Reference:

ITB16-018

VOLUNTARY SAFETY RECALL CAMPAIGN OCCUPANT CLASSIFICATION SYSTEM CONTROL UNIT REPLACEMENT

CAMPAIGN ID #: R1606
NHTSA #: 16V-244
APPLIED VEHICLE: 2013 JX (L50)
2014-2016 QX60 (L50)
2014-2016 QX60 Hybrid (L50)
2014-2016 Q50 (V37)
2014-2016 Q50 Hybrid (V37)

Front Passenger Air Bag Status Light

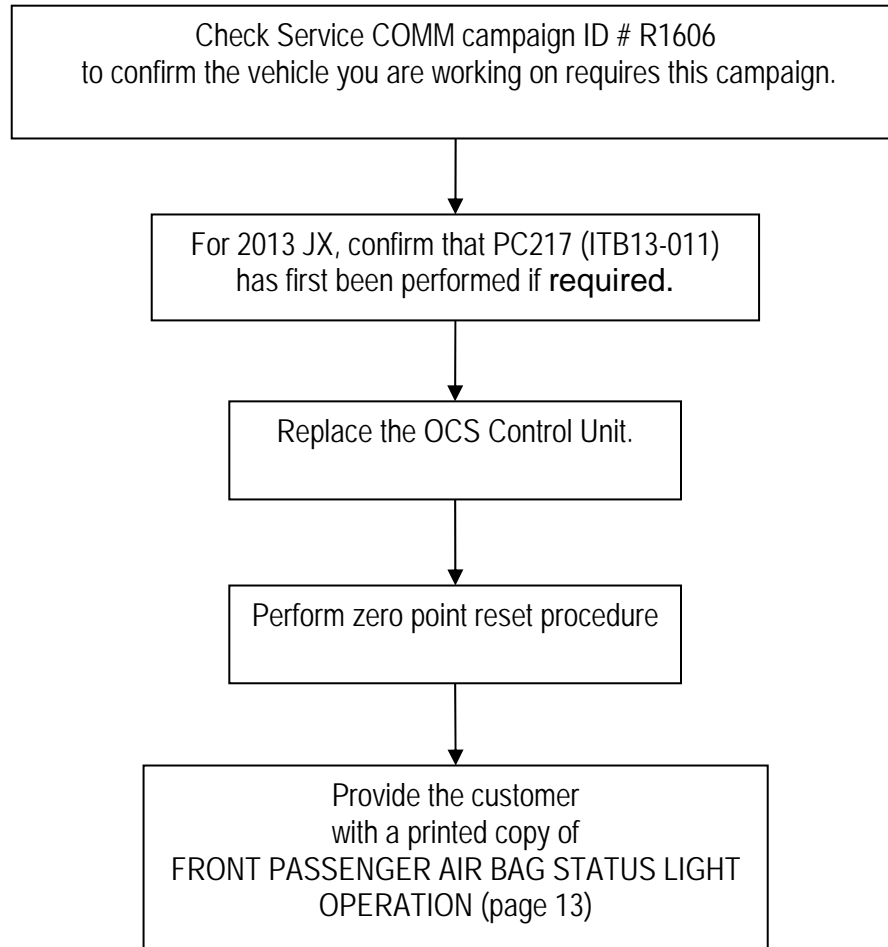
Performing the procedures in this bulletin (campaign R1606) changes the operation of the passenger air bag status light.

- After performing this campaign, the passenger air bag status light will be ON (illuminated) when the front passenger seat is empty.
